| SITE PLAN | | |
|---|------|-------------|
| CONVENIENCE STORE #1078 WITH 1 BAY ATTACHED CW | | |
| INWOOD AVE LAKE ELMO, MN | | |

Re: Inwood 6th Addition – Kwik Trip
Preliminary Plat Review

To: Ken Roberts, City of Lake Elmo Planning Director
From: Lucius Jonett, Wenck Landscape Architect
Date: July 22, 2019
Subject: City of Lake Elmo Landscape Plan Review
Kwik Trip Store #1078, Review #1

1078 L1

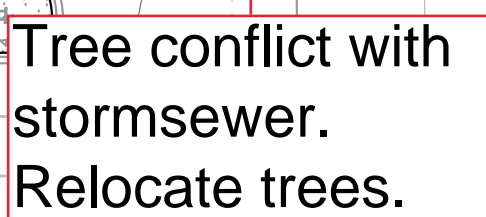
1. The submitted landscape plan does not meet the required number of trees. 3 Additional trees are needed to account for the Perimeter Parking Lot Frontage.
2. The proposed development has perimeter parking along 5th Street that requires perimeter parking lot landscaping.
3. One tree was found to be in conflict with sidewalk and curb setbacks and should be relocated to elsewhere on the property. See attached markup plan.
4. Two evergreen trees are in conflict with proposed stormsewer and should be relocated to elsewhere on the property. See attached markup plan.
5. 6" of topsoil is required versus the 4" of topsoil stated in the notes. See attached markup plan.

6" Depth of topsoil required.

1. Submit a revised landscape plan to address the findings above.
